Using the World's Most Accurate Frequency Standard

The above-mentioned project is a three-part series which appeared in the January, February, and March 1994 issues. There is a slight error on the PC board layout for Part 1,

Figure 1.a) New artwork for the WWVB Receiver. b) A simple cut-and-jumper fix for the original artwork.

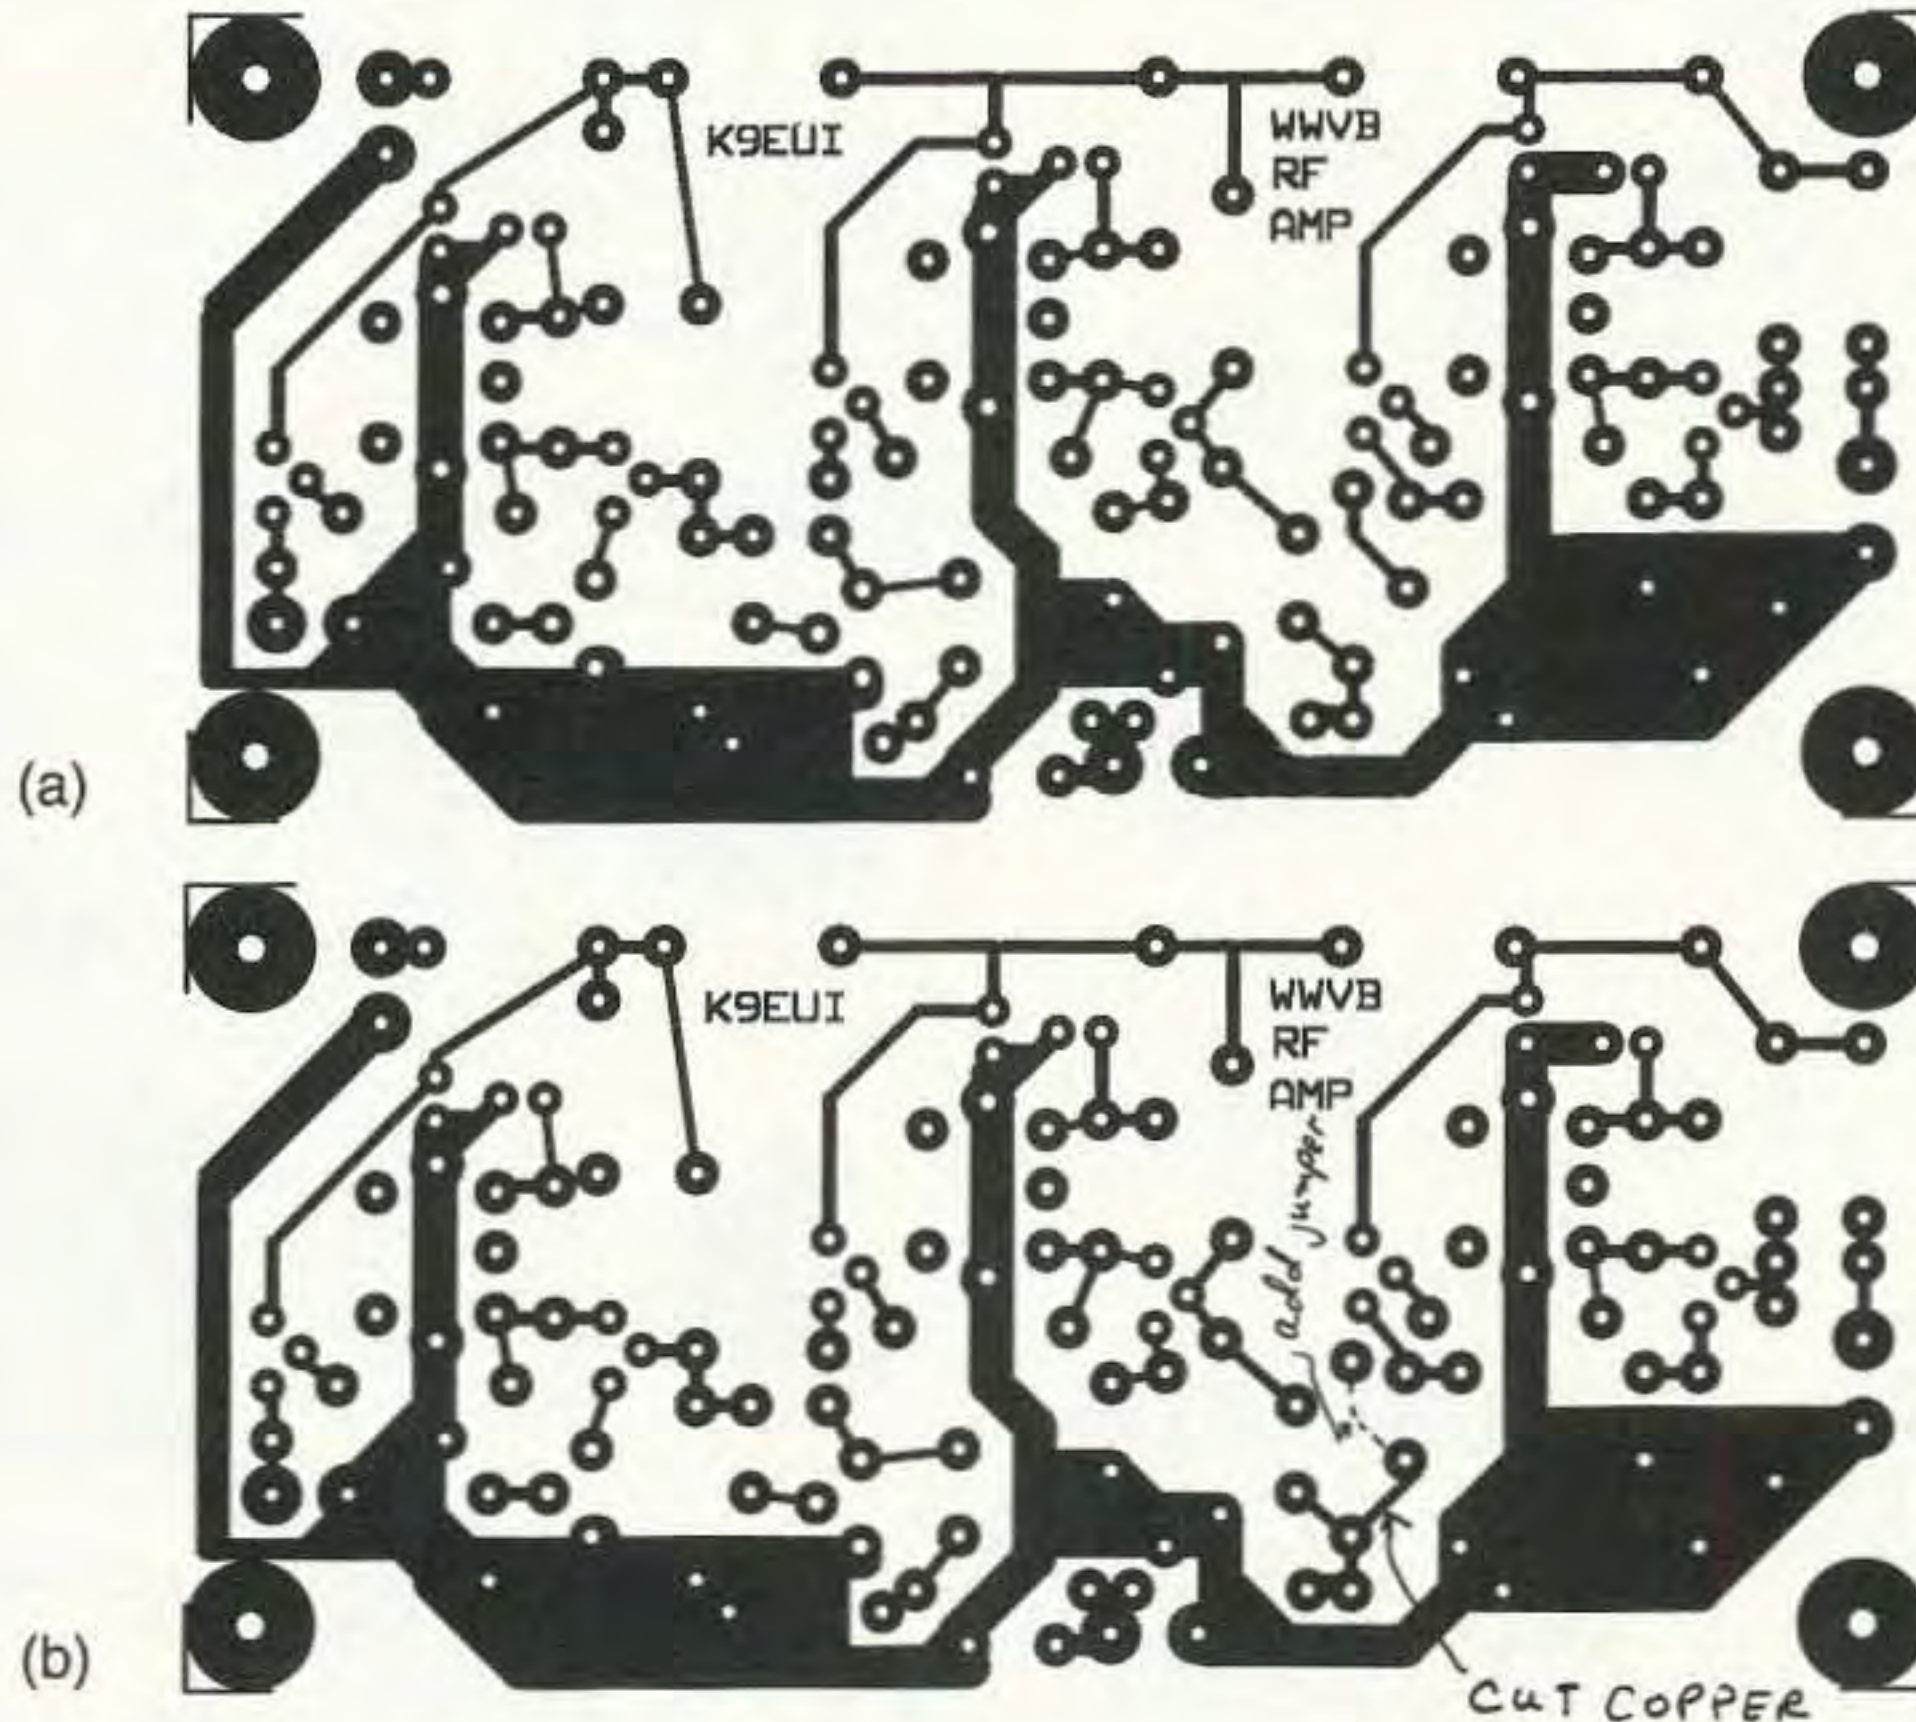
the WWVB Receiver, which appeared in February, page 23, Figure 5. Shown below is the correct foil pattern and a simple cut-and-jumper fix for the one we printed. The RF amp will still work without this fix; it just won't work very well. 73
